Addendum # 2

Bid Opportunity: 26-7904-RFT - Old Riverside Public
School Demolition of Structure

Sod Installation and Establishment Notes/Specifications

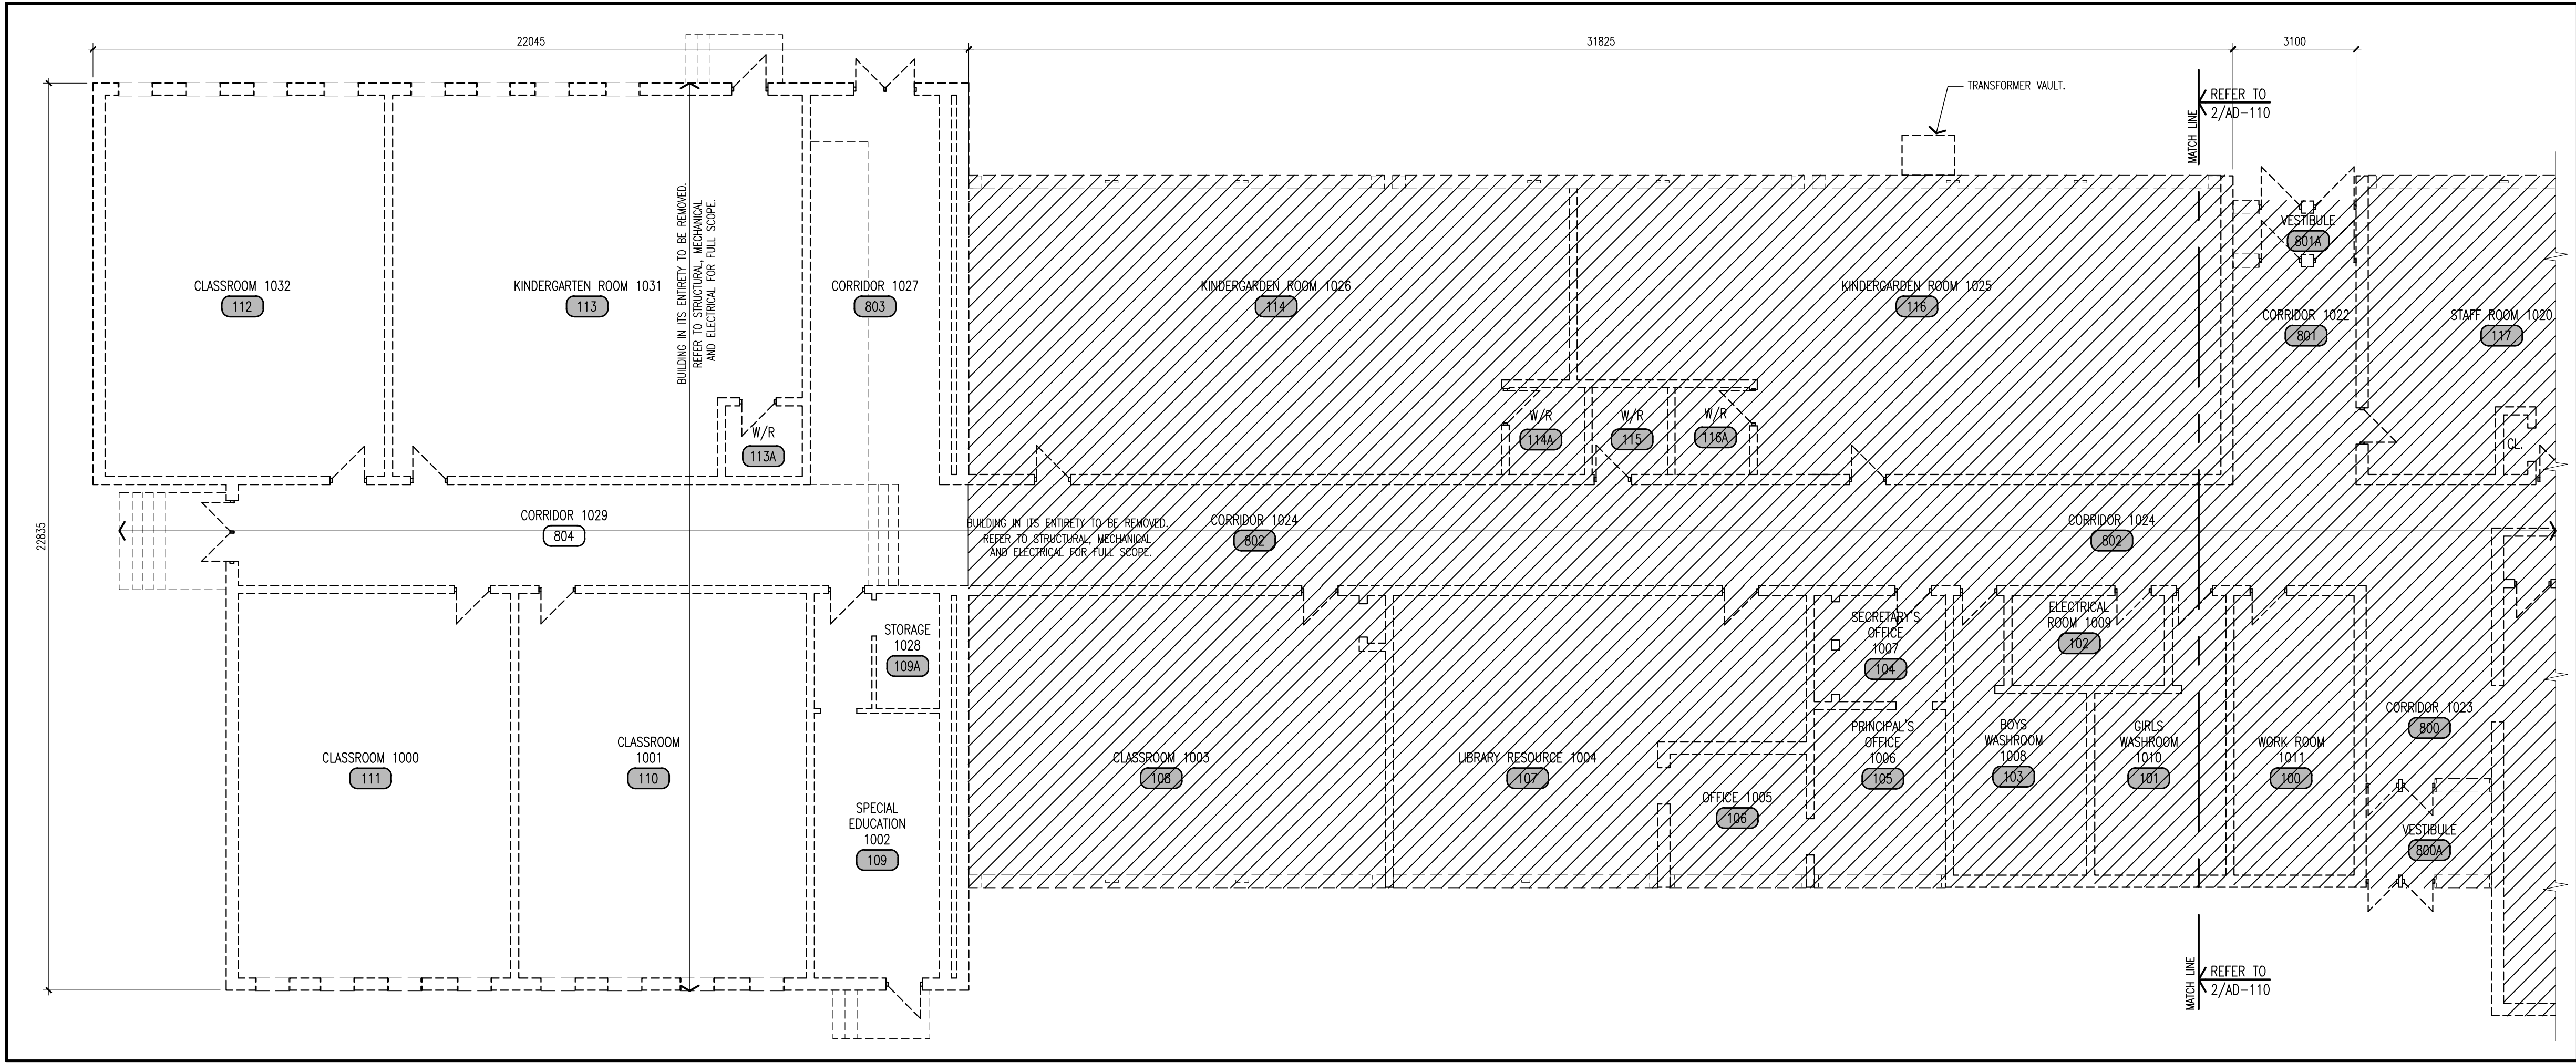
Please verify the need for new sod and topsoil and provide their specs (if required).

Section 00 21 15 specifies new sod, while the Post-Demolition Grading Plan identifies areas of topsoil and seed.

Please confirm the required final surface treatment, topsoil thickness, acceptable backfill material, compaction requirements, and responsibility for compaction testing.

Answer 1: Refer to the attached '*Sod Installation and Establishment Notes/Specifications*'.

Answer 6: Landscape restoration is to be new sod. Refer to the attached '*Sod Installation and Establishment Notes/Specifications*'.

drawing title	
FLOOR PLAN — DEMOLITION	
reference	
project no. 26—020	client reference number
sheet no.	
AD11001

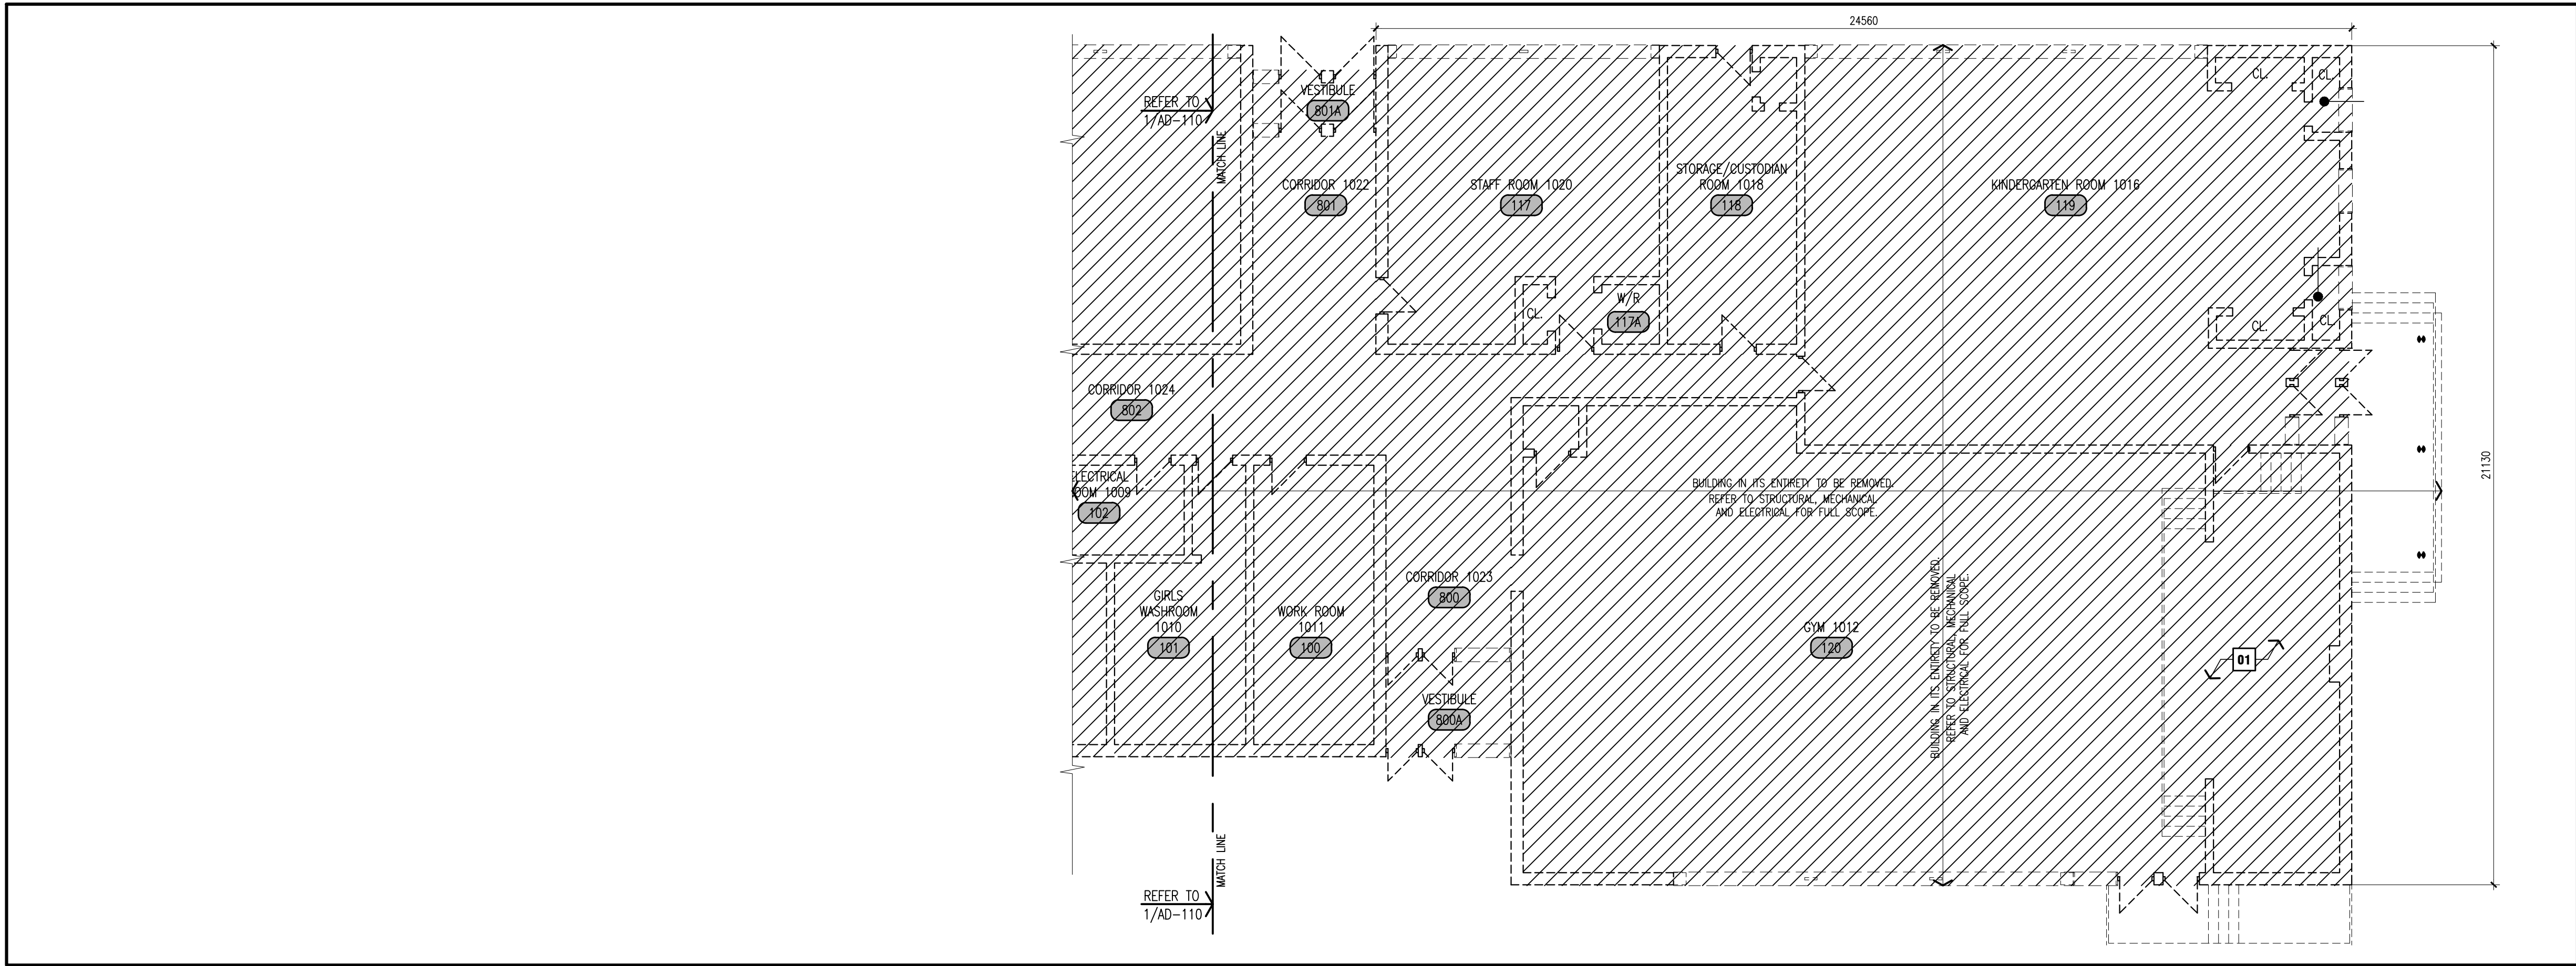
The Asbestos Report is hard to determine what needs to be removed per room as the room labels in the report do not match the room number labels on the drawings. Can this be made into an allowance?

Answer 14: Refer to updated architectural plan AD-110 attached which includes the room numbers that are indicated in the Asbestos report. Abatement work is to be included in the base bid.
